UNITED STATES DEPARTMENT OF COMMERCE United States Patent and Trademark Office Address COMMISSIONER FOR PATENTS PO Box 1450 Alcassedan, Virginia 22313-1450 www.emplo.gov

APPLICATION NO.	FILING DATE	FIRST NAMED INVENTOR	ATTORNEY DOCKET NO.	CONFIRMATION NO.	
10/573,785	03/28/2006	Christophe Taurand	4590-503	5497	
33308 HAUPTMAN HAM & BERNER, LLP 1700 DIAGONAL ROAD, SUITE 300 ALEXANDRIA, VA 22314			EXAM	EXAMINER	
			TRAN, NGUYEN		
			ART UNIT	PAPER NUMBER	
			2838	•	
			MAIL DATE	DELIVERY MODE	
			11/24/2009	PAPER

DETAILED ACTION

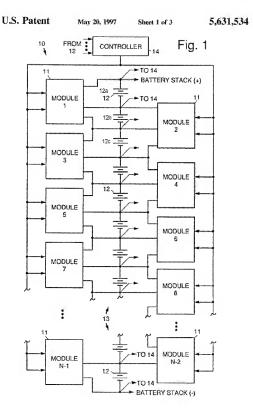
Claims 10-11, 14, and 20 are rejected under 35 U.S.C. 102(b) as being anticipated by Lewis (US 5631534).

Regarding claim 10: Kutkut et al. discloses fig. 1 an energy storage device comprising n storage elements (i.e. battery 12) arranged in a series network (network of fig. 1), said network (network of fig. 1) able to provide a continuous voltage across its terminals (terminals of 12), and n(n-1)/2 identical charge transfer modules (i.e. 1-3), each module (i.e. 1) pairing two storage elements (i.e. first battery 12a and second battery 12b of figure 1) of the said network and ensuring a bidirectional transfer of charge between these two storage elements (i.e. first battery 12a and second battery 12b of figure 1), and each storage element (C.sub.k) (i.e. 12b) being paired with each of the other n-1 storage elements (12a and 12c) of the network by (n-1) associated

modules (i.e. module 1 and 2) (i.e. storage element 12b is being paired with storage 12a of the network by associated module 1, and storage element 12b is being pared with storage 12c of the network by associated module 2) (see figure provided below).

Regarding claim 11: fig. 1 wherein said modules (i.e. the connection between modules1-3) are of the three-pole or four-pole type depending on whether the elements that they pair are adjacent or nonadjacent.

Regarding claim 14: fig. 1 wherein the charge (charging current) transfer between a storage element 12 and the storage elements (i.e. 12a-c) which are paired with manifests itself by a charging (charging current) or discharging current of these paired elements proportional to first order to the difference between the voltage at the terminals of the said element and the average of the voltages at the terminals (i.e. terminals of 12) of the said storage elements (i.e. 12a-c) paired with.

Regarding claim 20: fig. 1 an electronic system comprising a charger 12 and an energy storage device as claimed in claim 10, said energy storage device 12a-b being rechargeable by the said charger 12.
